AGENDA
Regular Planning Board Meeting
March 23, 2021 - 6:30 PM
TOWN HALL (101 Huntersville-Concord Road)

**Town of Huntersville
Planning Board
March 23, 2021**

Subject: Alternate Buffer Plan - Belts Services

Trails End Subdivision Sketch Plan

C1.0 - SITE PLAN

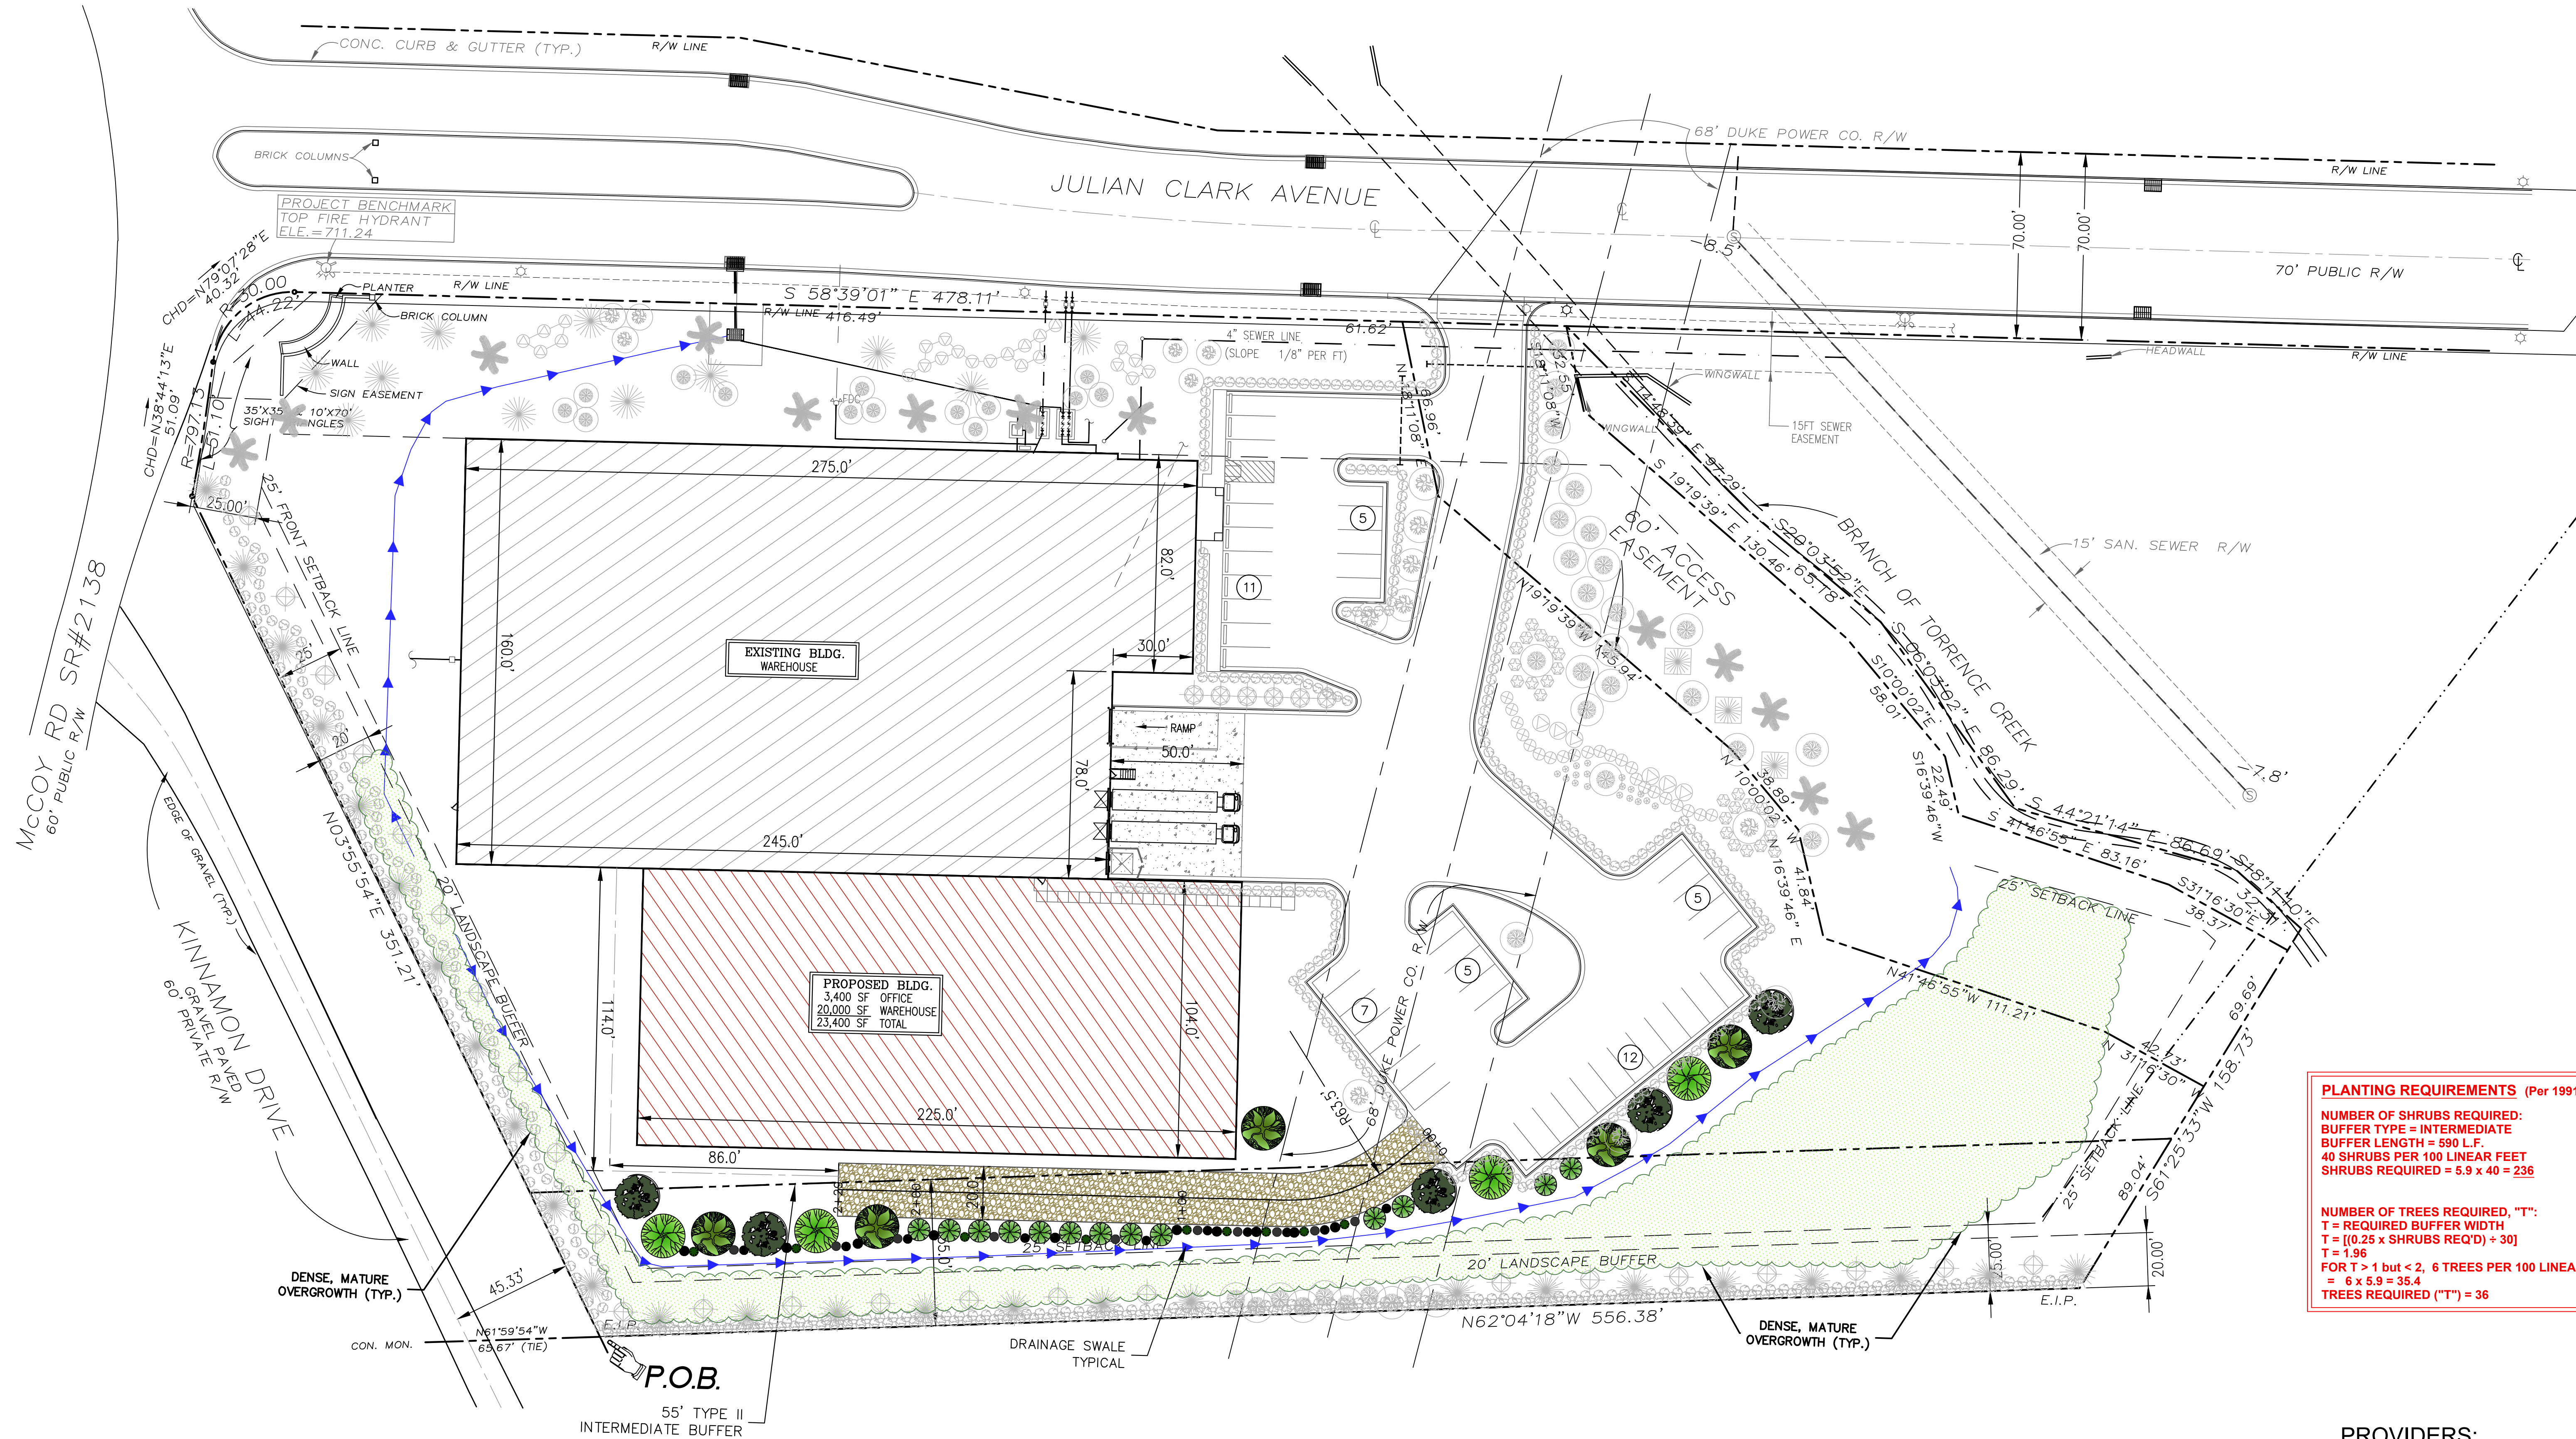
- Article 71.140.5 requires that buffers remain undisturbed except for specific circumstances like sidewalks, required driveways, pedestrian or bicycle paths, walls, or fences.
 - The applicants are proposing an alternate buffer plan to modify this requirement as well. See the alternate buffer plan above. The emergency fire access is proposed to be located in between the proposed expansion and the buffer/property line to the south. No plantings would be located in this area. However the applicants have agreed to use geowebbing structure to accommodate fire truck weight with grass on top. The fire lane would thus be natural grass area but plantings would be prohibited.
 - Therefore the required distance of the 55 foot buffer would be maintained but the plantings would be limited to the existing vegetation and perhaps

- Article 71.150.1 allows the applicant to request a modification from the buffer requirements to use existing vegetation. Article 71.150.1 C states “If, but not unless, the Planning Board finds that the alternative buffer planting plan meets the intent of Section 71.140.3 and 71.140.4 through the use of existing vegetation, or existing vegetation plus supplemental plantings, the Planning Board shall approve the alternative plan”.
- The applicants therefore are requesting approval of their alternative buffer plan to use existing vegetation as their required screening and to allow the fire lane to be located in the buffer.

Staff recommends approval of the alternate buffer plan with the addition of one row of evergreen trees along and south of the fire lane (with tall evergreen shrubs under the power line). The existing vegetation to the south of the property is significant. Please see aerial photos of the site above on page 3, and site photos taken by the applicant and attached to the grading plan (included in the agenda packet). It seems both evergreen and deciduous vegetation is present at about 35 feet in width from the southern property line. In addition, Courtyards at Kinnamon Park have planted a 20 foot buffer along their northern property line.

There are however some gaps in the buffer where no trees are present and most of the vegetation consists of mostly low overgrowth. Therefore staff recommends the visual separation intended in Article 71.140.3 and 71.140.4 would be met with one additional row of evergreen trees to add supplemental height to the buffer.

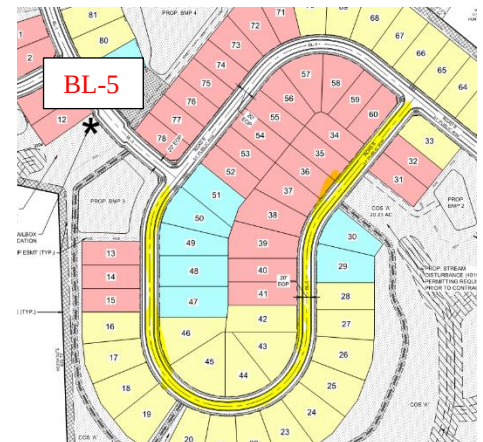
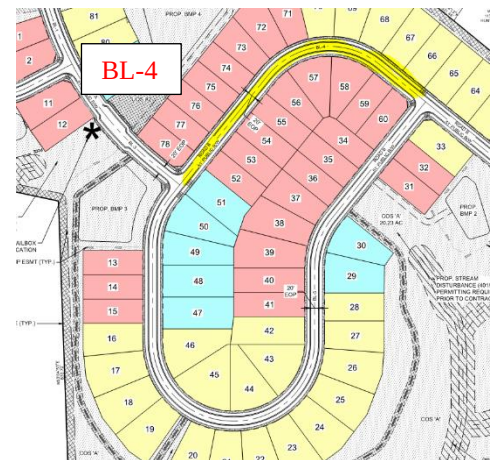
Block Length 4 (highlighted on image to the right above) is 817 feet and Block Length 5 (highlighted on the to the right below) is 1,743 feet

Staff supports this modification request due to the topographic nature of the site and location of SWIM buffers (see map on page 3-red indicates steep slopes).

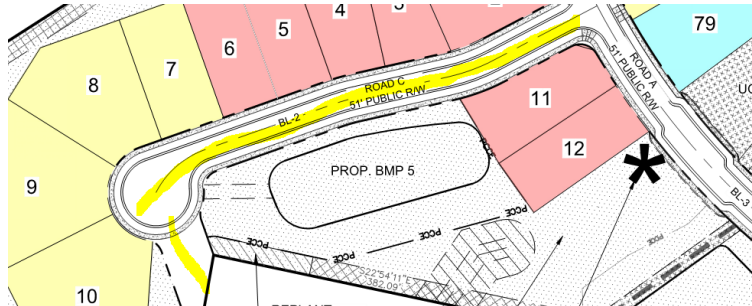
12. Currently, Road C (below) is measuring 517’ and per Article 7.150, Cul-de-sacs may not be longer than 350’. This requirement can be waived where topographical or other unusual conditions exist.
 - a. *Currently, it is unclear how the developer will address this.*

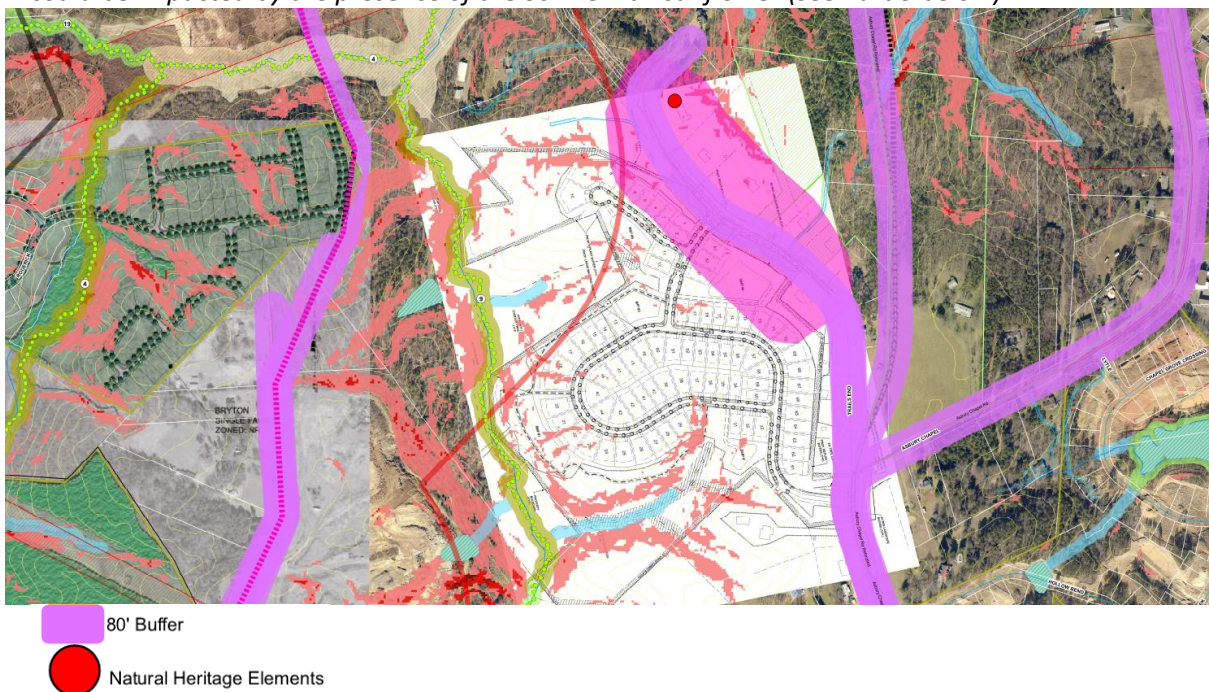
The below map indicates there is a **potential** Natural Heritage Element of Federal and State Threatened and Endangered Species on this property (Schweinitz' Sunflower-red area below). Attachment "D" is an environmental report from the applicant's consultant stating that "marginal habitat of this species is present in the open areas along the Trails End Road right-of-way and also the small powerline right of way that bisects this property." In addition, the report indicates "During the systematic survey of these areas, no individuals of Schweinitz' sunflower were observed." The report also states "...a thriving population on the opposite side of the road from the project site, along Trails End Road..." was observed (see below photo). The biological conclusion of the report is that the development "may effect, but not likely to adversely affect" the Schweinitz' Sunflower.

- a. The report indicates that the applicant will request that the US Fish and Wildlife Services provide a letter of concurrence or recommendations for advancing this project. At the date of this staff report, staff has not received this letter.
- b. Staff is trying to determine if road improvements required to Trails End as a result of this development could be impacted by the presence of the Schweinitz' sunflower (see Part 3 below).

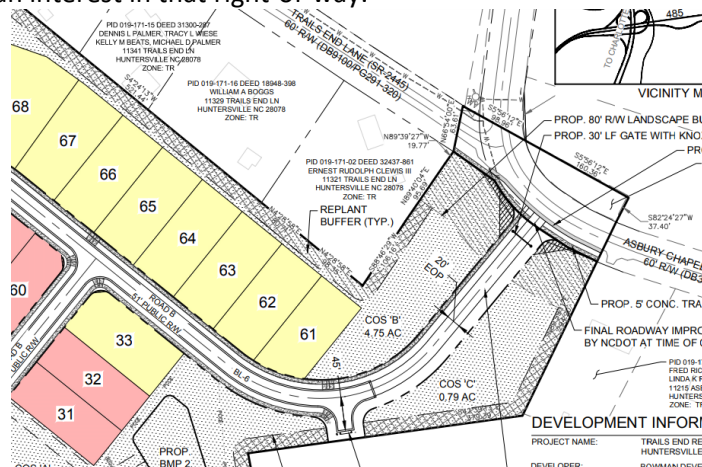
- Asbury Chapel Road is a minor thoroughfare, and the R/W line needs to be 35' from the road centerline. The plan is currently showing 30'.
